**Medway Planning & Economic Development Board
Meeting**

**Master's Touch Minor Site Plan Public
Briefing – 83 Main Street**

**Re: Master's Touch
Minor Site Plan Review
83 Main Street
Medway, Massachusetts**

DETAILS

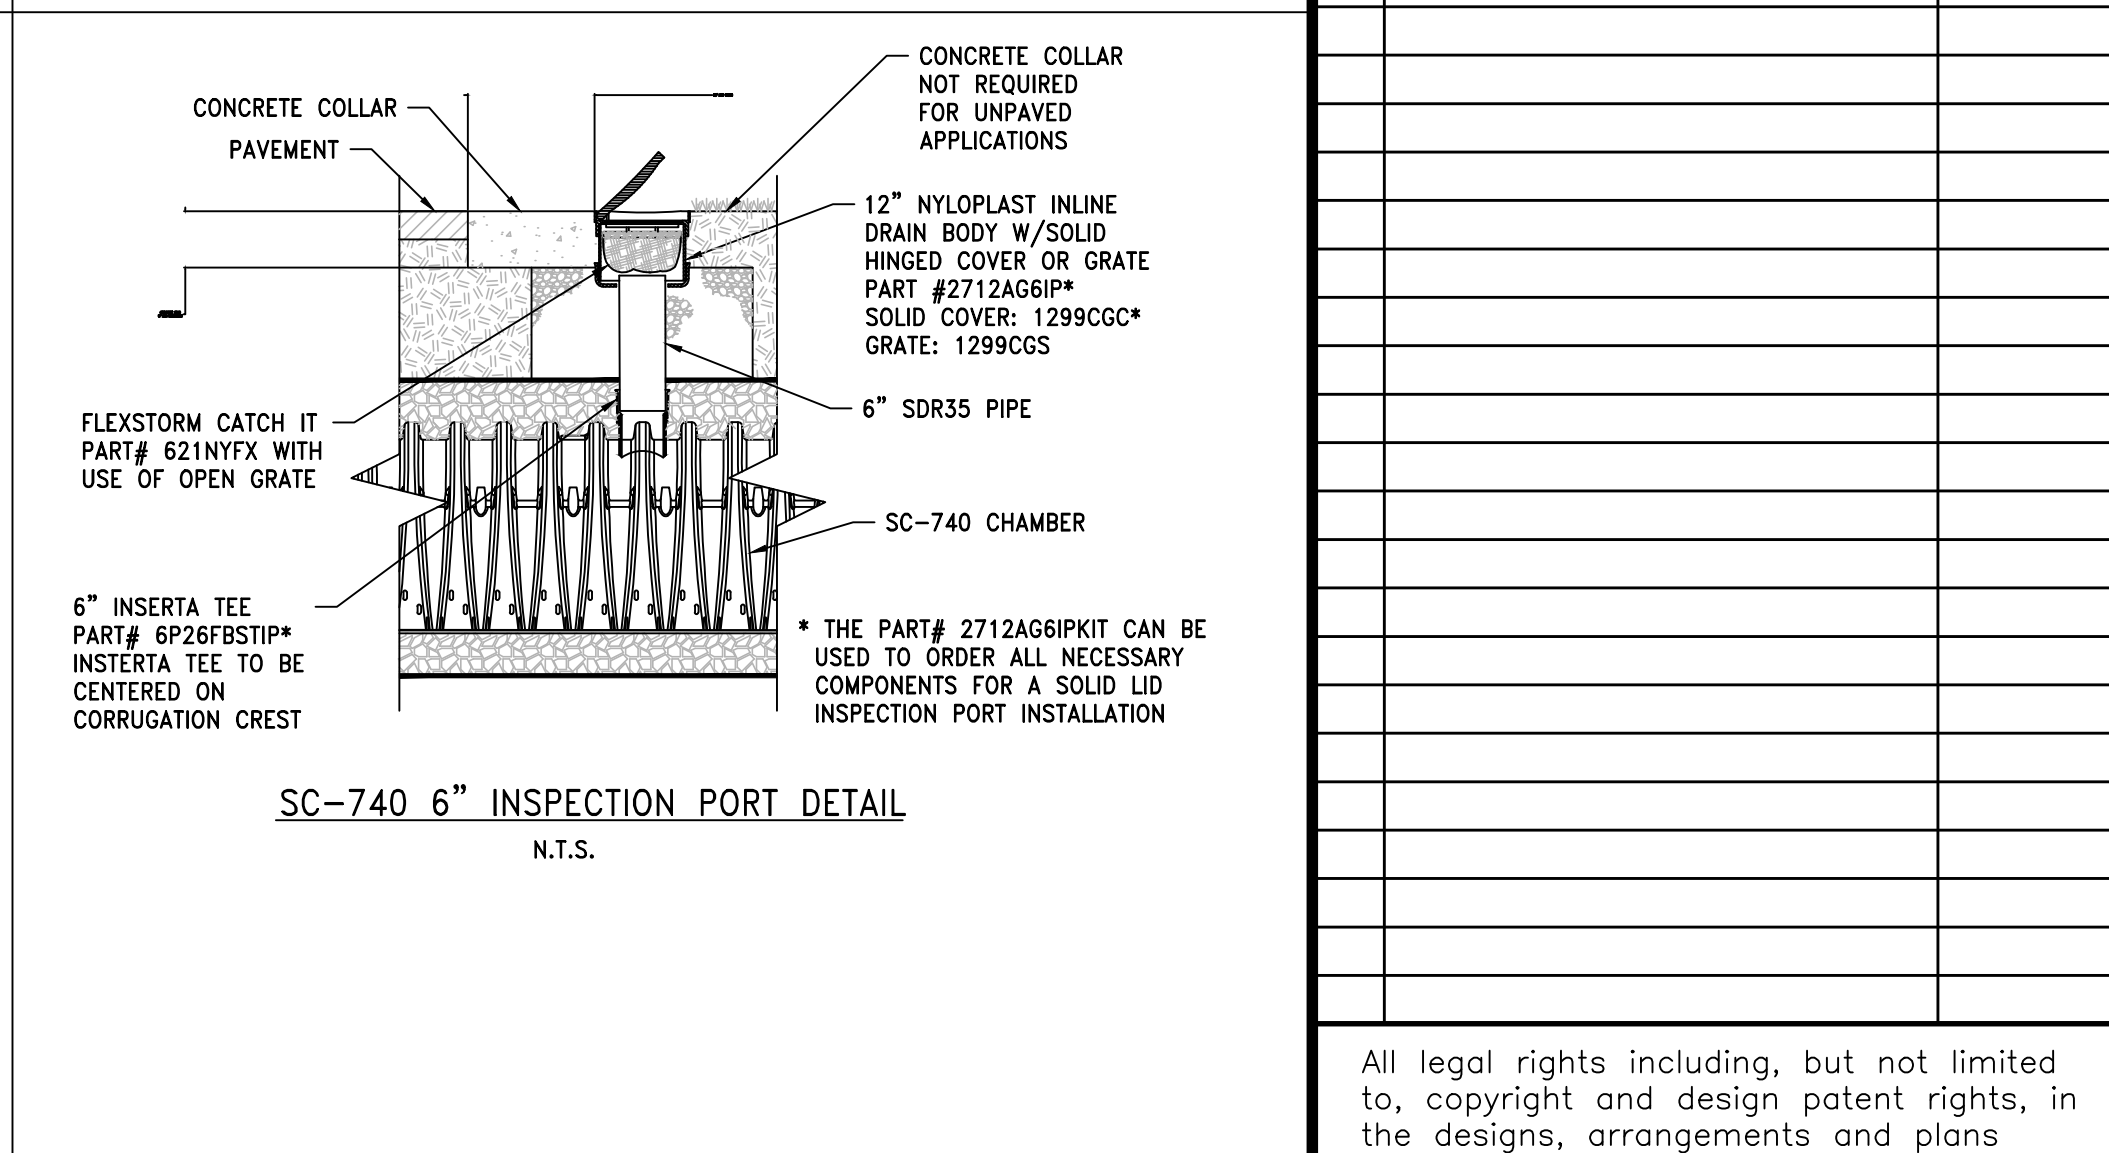
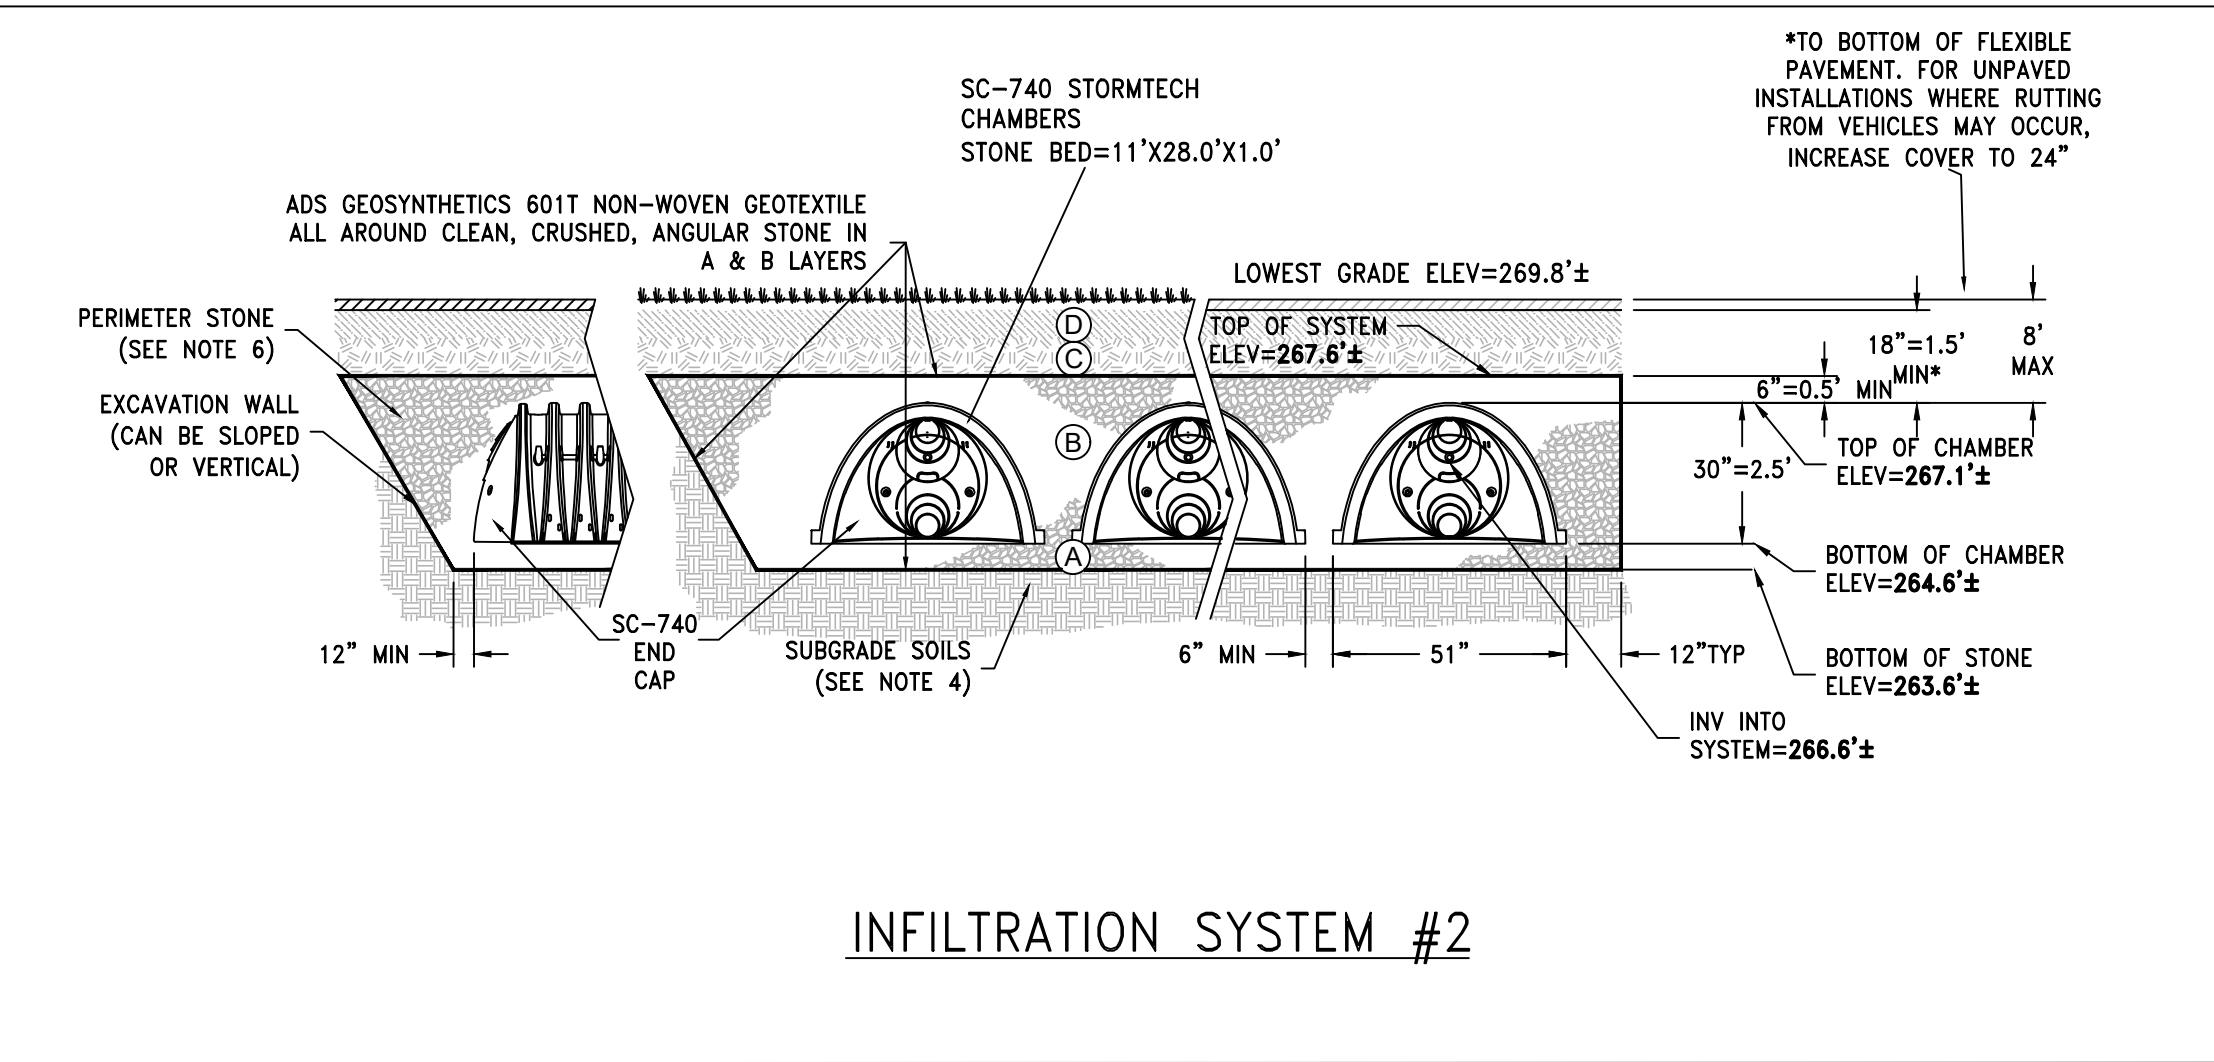
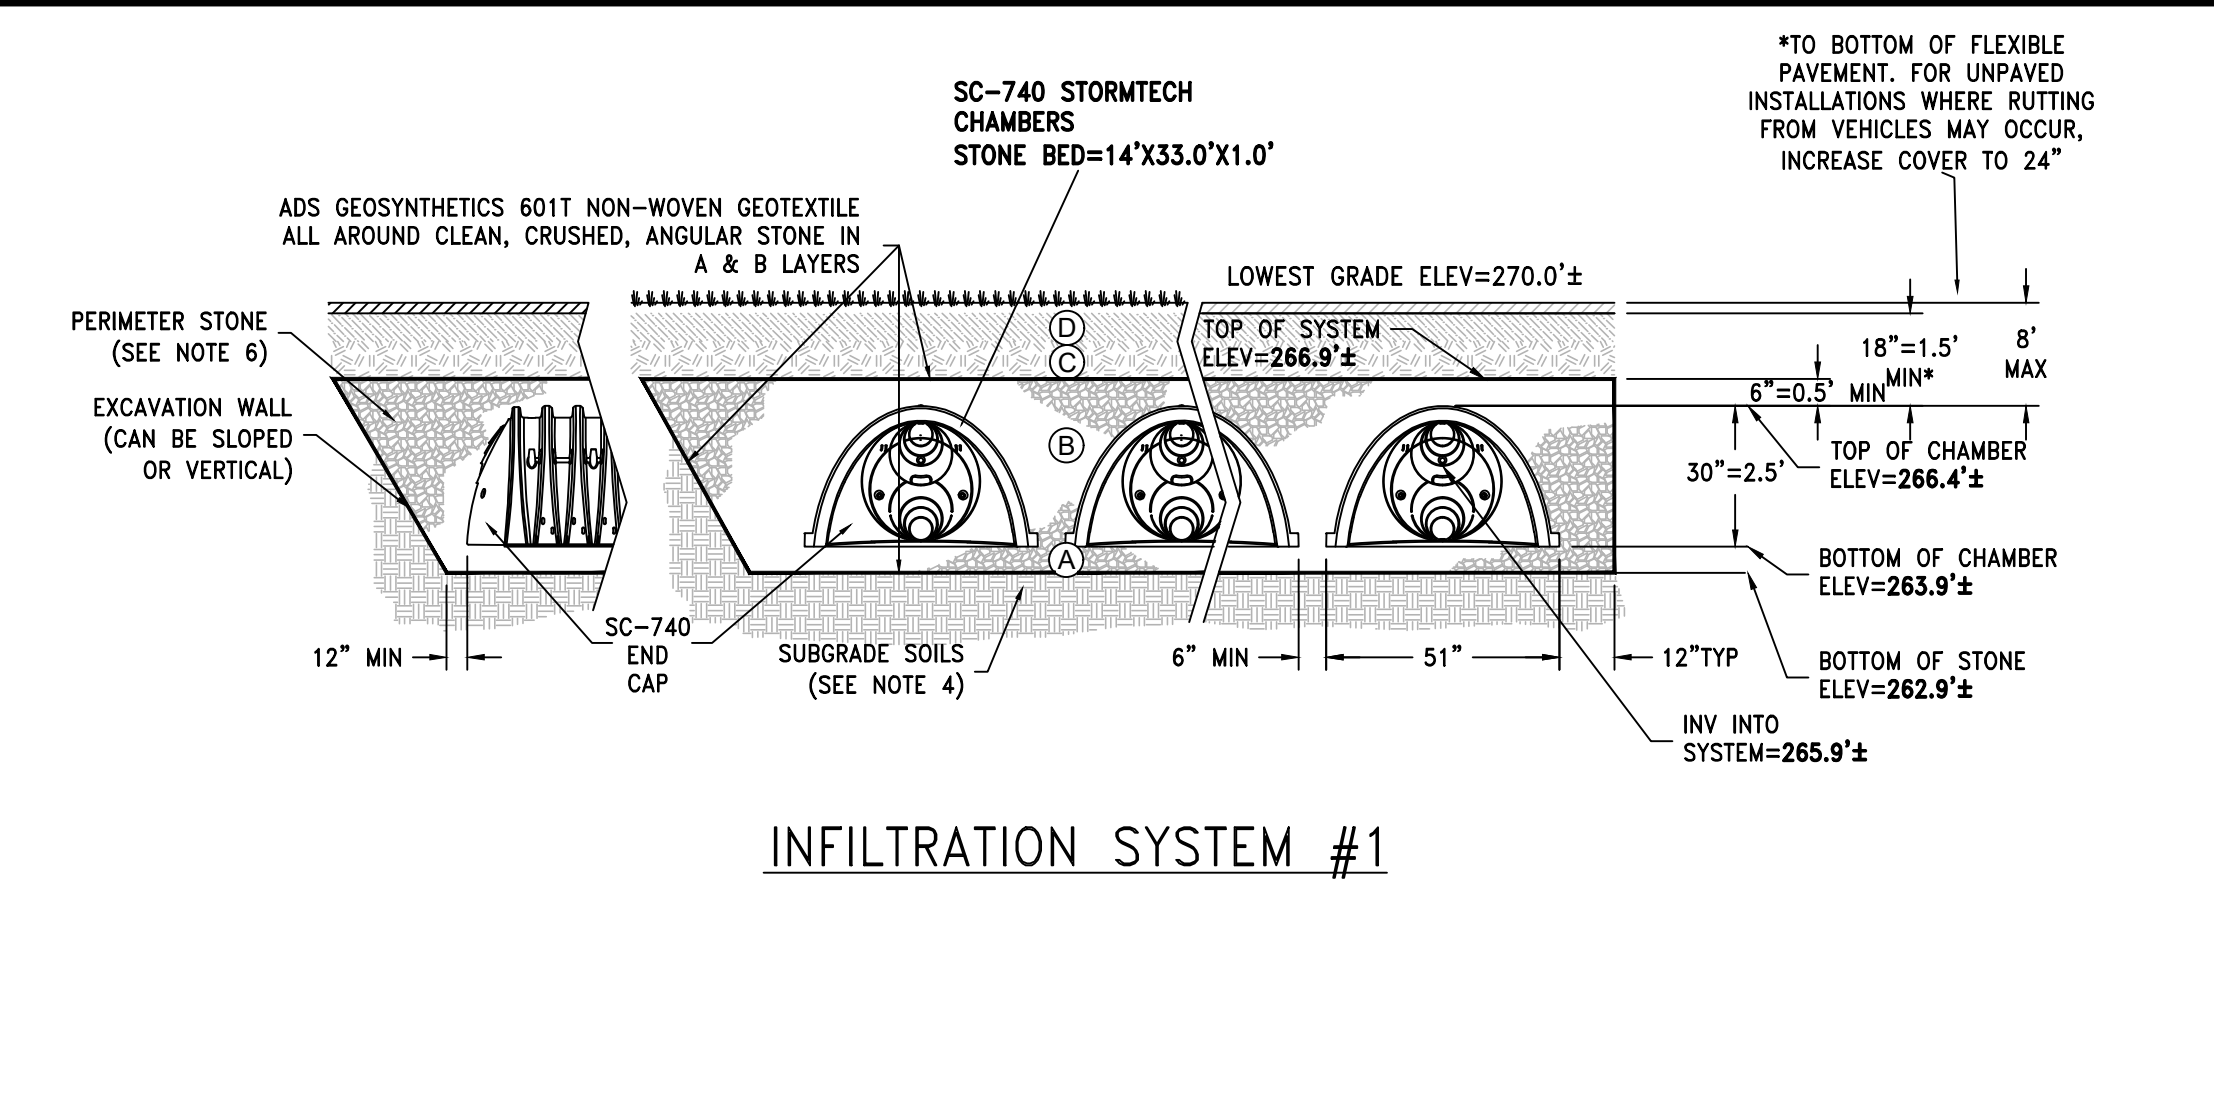
39. Recharge calculations were not provided in the Stormwater Report. (Standard 3)
40. The Applicant is proposing to use infiltration best management practices (BMP's) to mitigate the increase in stormwater runoff as a result of the proposed development of the site. The Applicant has not provided any test pit information to confirm soil texture and estimated seasonal high groundwater (ESHGW) elevation at the location of the proposed infiltration BMP's. (Standard 3)

54. We do not recommend placing fabric under the proposed Stormtech Systems as it may inhibit infiltration as sediment builds in the system.
55. The Applicant used "Wetted Area" to model exfiltration in the HydroCAD model. "Surface Area" shall be used in the model as all infiltration is considered to be vertical in the analysis.
56. The layout of the proposed Stormtech Systems does not appear to show typical installation method. Rows of chambers are typically connected to each other and then stone placed around the entire row(s).
57. Overflow devices should be added to the downspouts to ensure free flow of discharge from the roof drains in the event the SIS becomes over filled.
58. The Applicant proposed a bend in the pipe connection from Catch Basin #3. We recommend a manhole be placed at the proposed bend.
